DECISION OF THE PLANNING COMMISSION

**CLASS 3 DESIGN REVIEW / CONDITIONAL USE / CLASS 3 SITE PLAN
REVIEW / CLASS 2 ADJUSTMENT / CLASS 2 DRIVEWAY APPROACH PERMIT
DR-CU-SPR-ADJ-DAP20-02**

SUMMARY: An application to develop an 18-unit multiple family residential development, with associated site improvements.

CHARLENE'S HOUSE
APARTMENTS

PRELIMINARY SITE PLAN

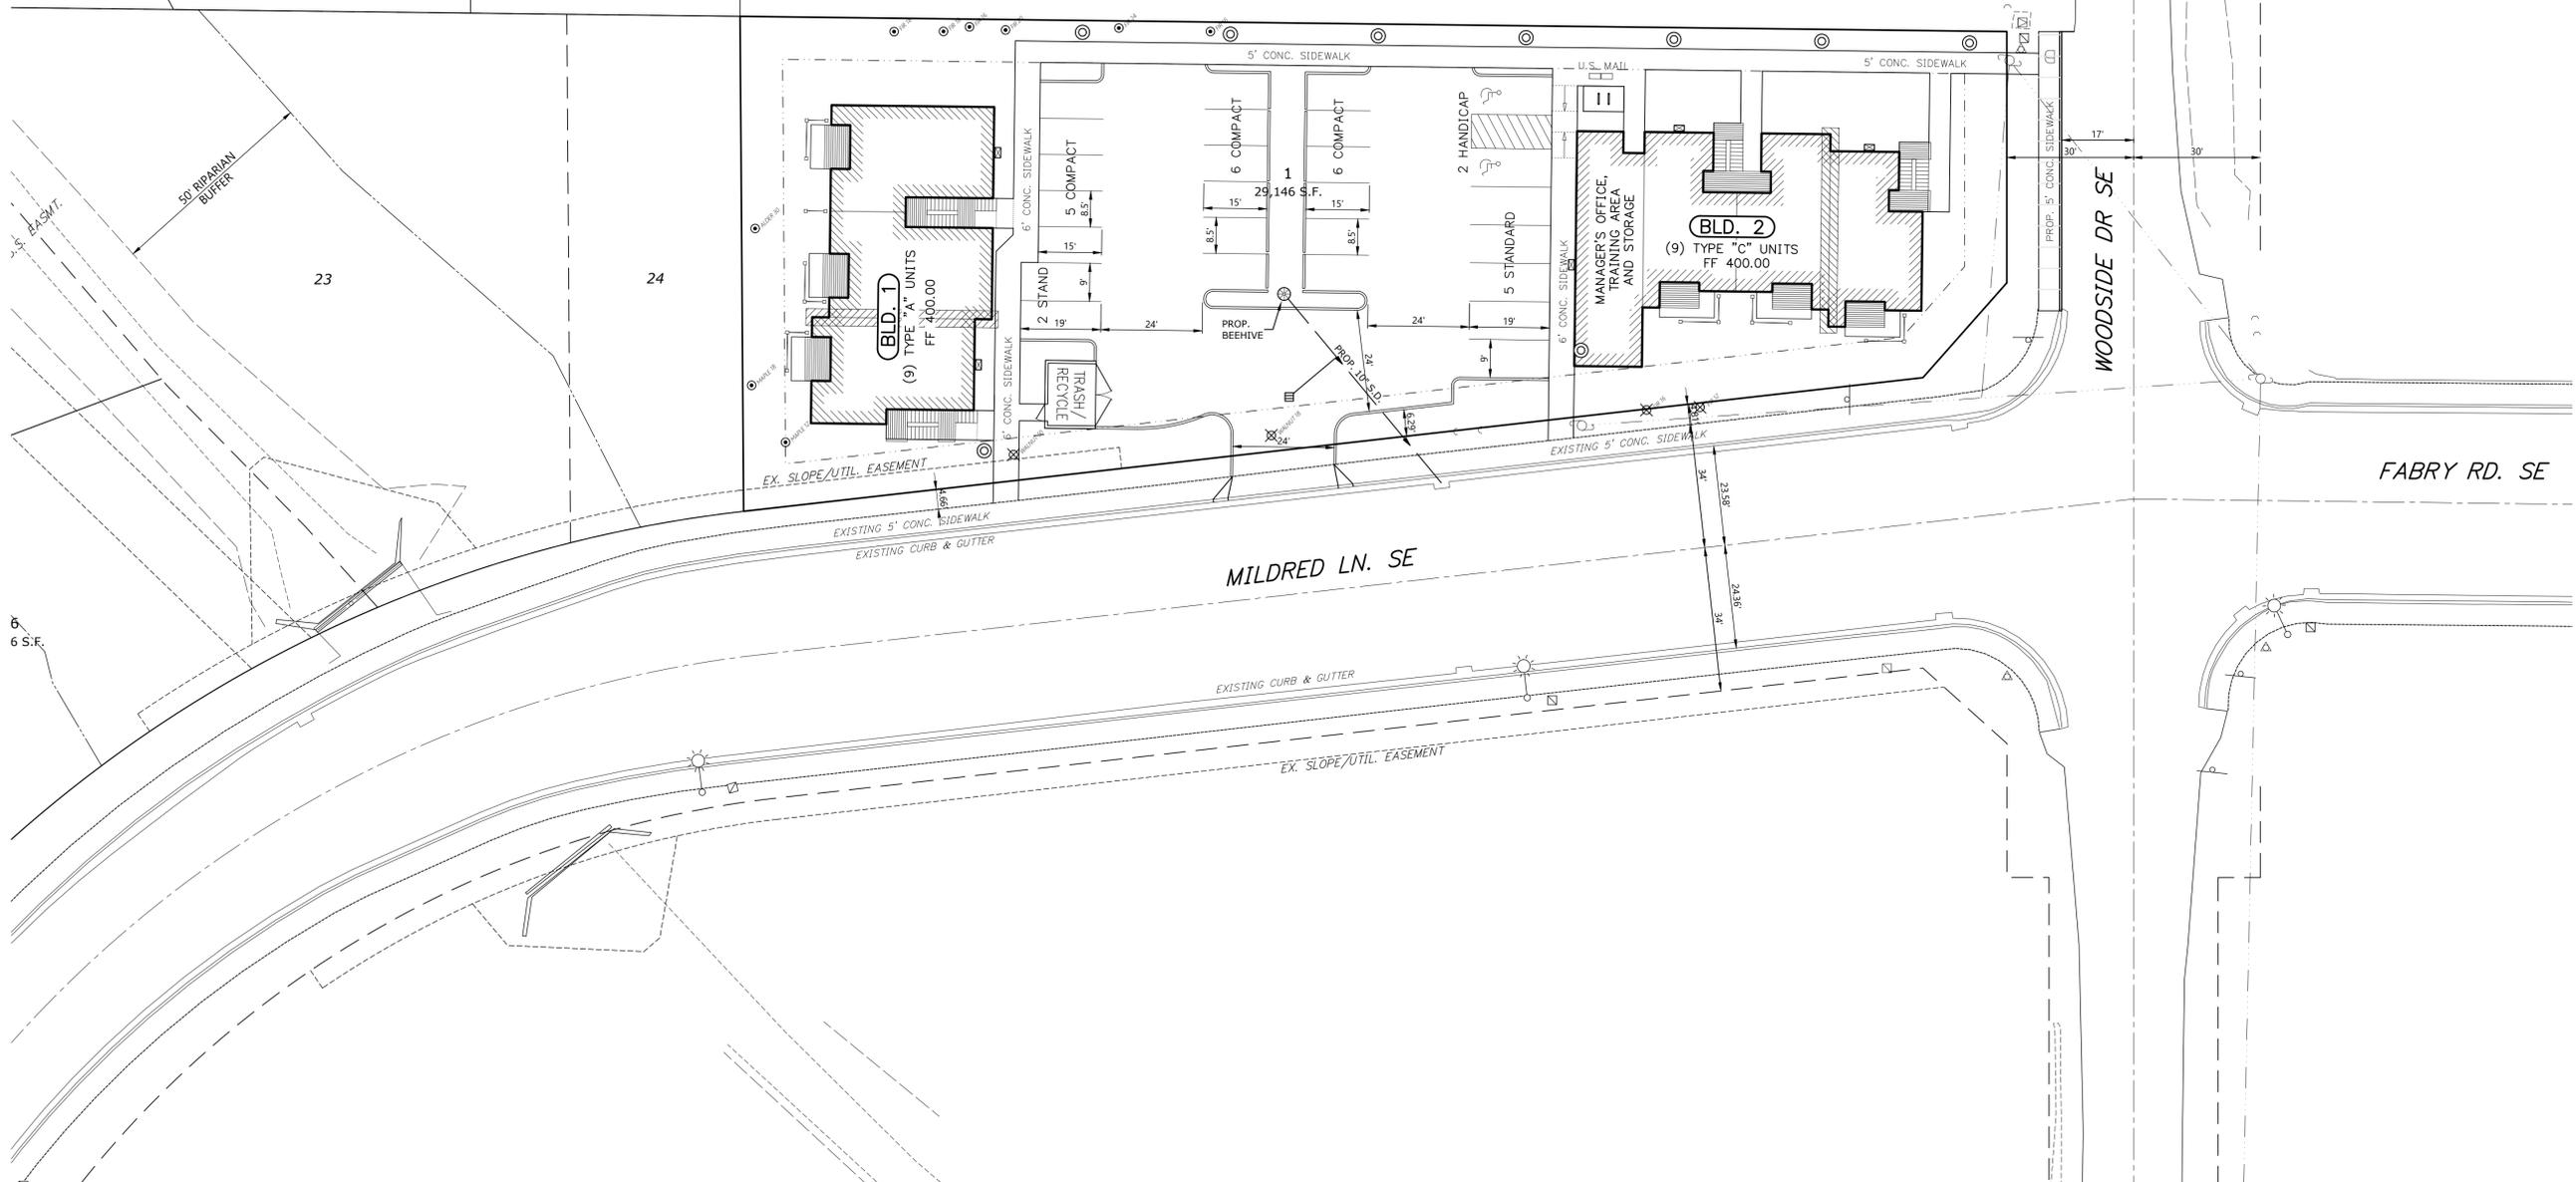
Condition 1: The nine trees identified on the proposed site plan for preservation shall be marked and protected during construction, or in the case of any tree removal, two new trees shall be planted for each tree

Condition 2: A minimum of two canopy trees shall be planted within the interior of the off-street parking area.

Condition 3: On both sides of the proposed driveway approach, provide a minimum of one tree as well as a 30-inch-tall brick, stone, or finished concrete wall to buffer the off-street parking area from Mildred Lane SE. The setback areas shall be landscaped according to the Type A standard set forth in Salem Revised Code Chapter 807. Any portion of the wall that encroaches into a vision clearance area set forth in Salem Revised Code Chapter 805 shall have a height no greater than the maximum allowed under Salem Revised Code 805.010.

Condition 7: At the time of building permit application, revise the off-street parking area to meet the 15-foot minimum setback to the north property line for the vehicle use area; or adjust this standard through a land use action.

Condition 9: Provide bumper guards or wheel barriers so that no portion of a parked vehicle will overhang or project into required setbacks and landscape areas, or into pedestrian accessways.
